Report: TAB Report
Function: Test, Adjust, & Balance
Date: 02/28/2025
Completed By: National TAB

PROJECT
02-10-25 WAWA #5459 STARKE, FL

Project Summary

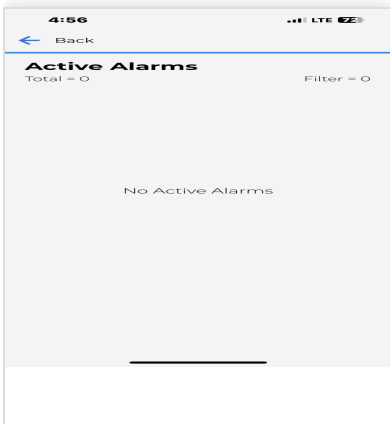
Issue Name : RTU 1 - Alarm 14
Description : RTU 1 is displaying Alarm 14 - High Pressure Switch Compressor 2. Compressor 2 is locked out. Recommend servicing.
Created By : National TAB **Assigned To :** National TAB - Dan Hertenstein
Status : Open
Priority : High **Asset Tag :** RTU1
Originated Date : 02/12/2025 - Mark Johnson - National TAB

- **03/04/2025 National TAB - Kristopher Passley**
 - Issue is resolved: No alarms on unit.

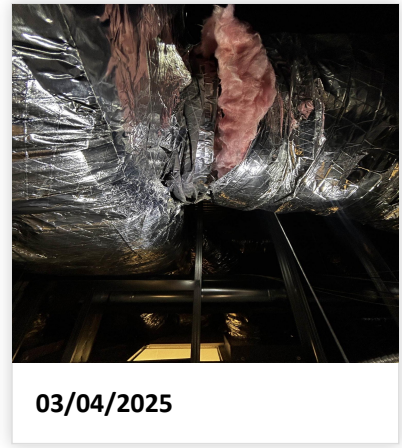
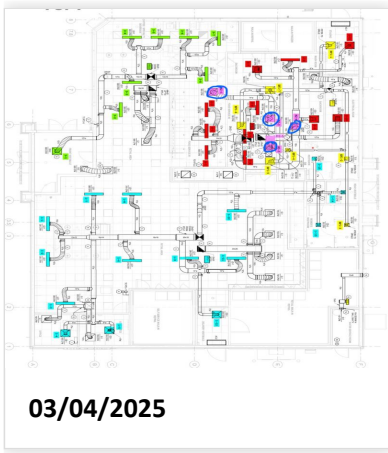
Issue Name : RTU 2 Returns - No Dampers
Description : Dampers are not installed or could not be located for RTU 2 return diffusers. Recommend installing to allow for balancing.
Created By : National TAB **Assigned To :** National TAB - Dan Hertenstein
Status : Open
Priority : High **Asset Tag :** RTU2
Originated Date : 02/12/2025 - Mark Johnson - National TAB

- **03/04/2025 National TAB - Kristopher Passley**
 - Issue is still present: RTU-2 Return dampers are not installed R2-1, R2-2, R2-3, R2-4. Recommend having mechanical install dampers so the return vents can be balanced.

- Recommend installing Return dampers for RTU-2 grilles at the discretion of WAWA CM and EOR. Since there are return grilles on both sides of a wall, recommend install so space/room pressures are properly maintained and balanced.
-
